PROPOSED RADIOLOGICAL EFFLUENT AND
ENVIRONMENTAL MONITORING SPECIFICATIONS

Response to NRC Comments on the first draft of the H. B. Robinson Unit #2 Radiological Effluent Technical Specifications (RETS).

Figure 1.2-1 Discharge Points to Unrestricted Waters
for Liquid Effluents

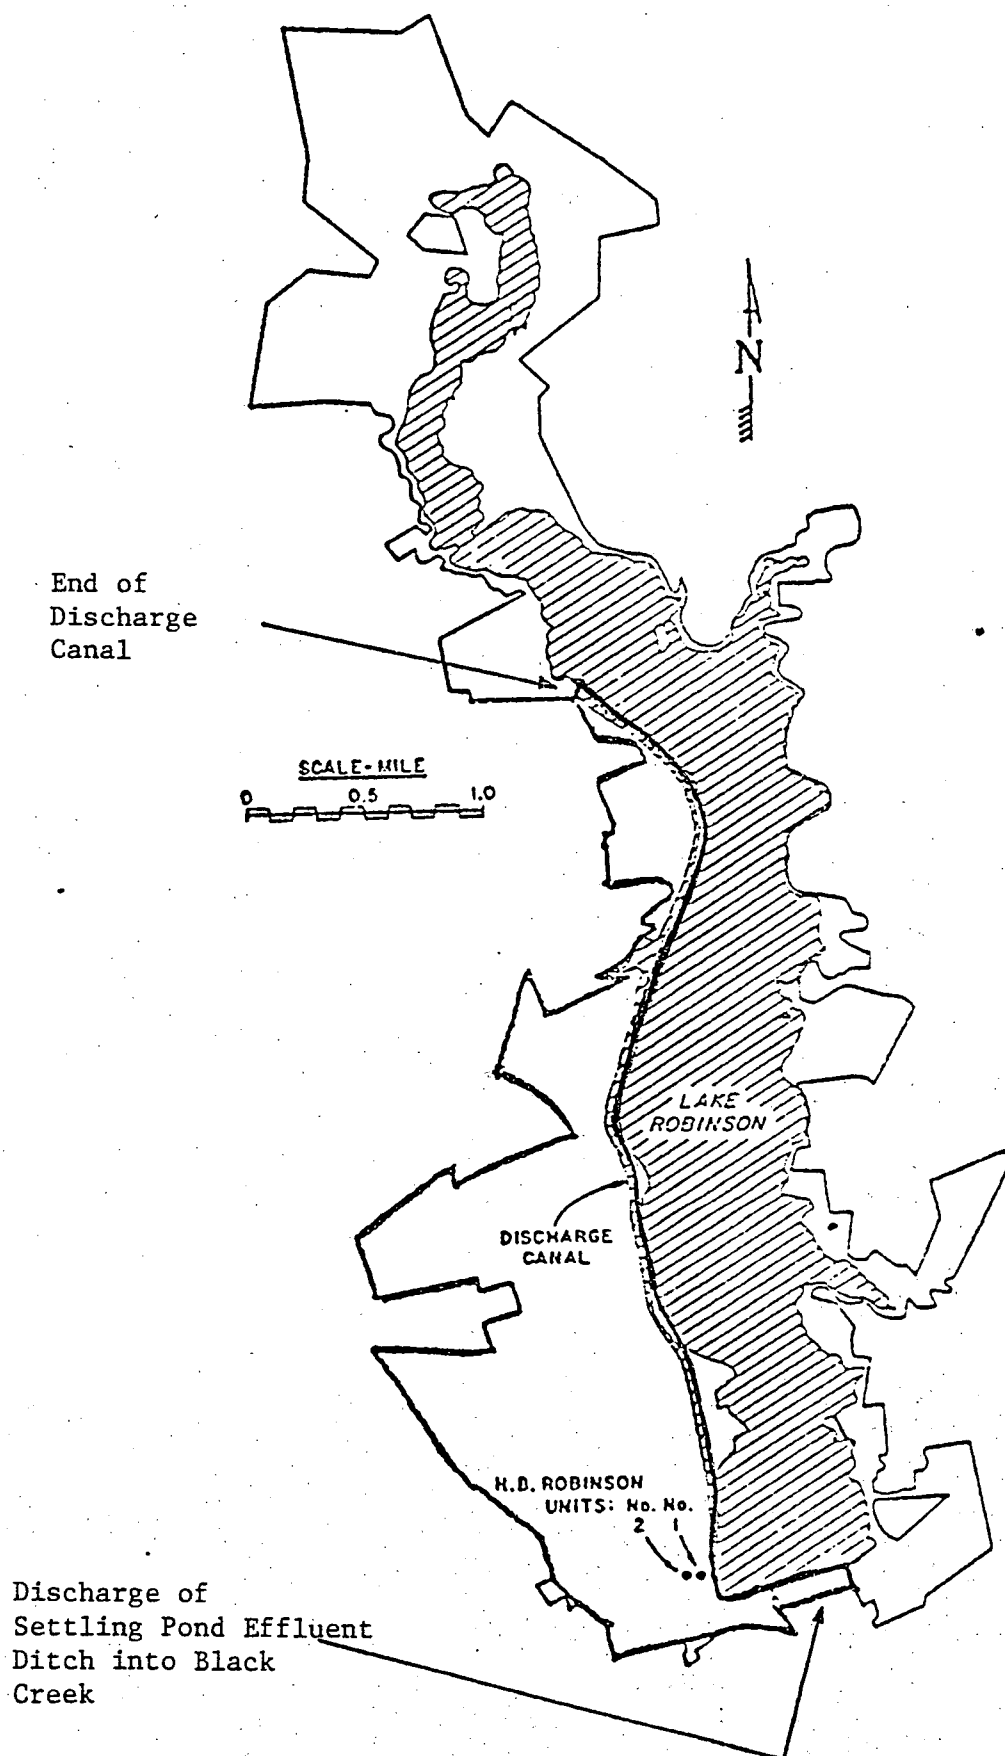
Figures 1.1-1 and 2.1-1 are not acceptable. Provide maps clearly defining the site boundary and restricted area boundary, and in accordance with the instructions in the markups.
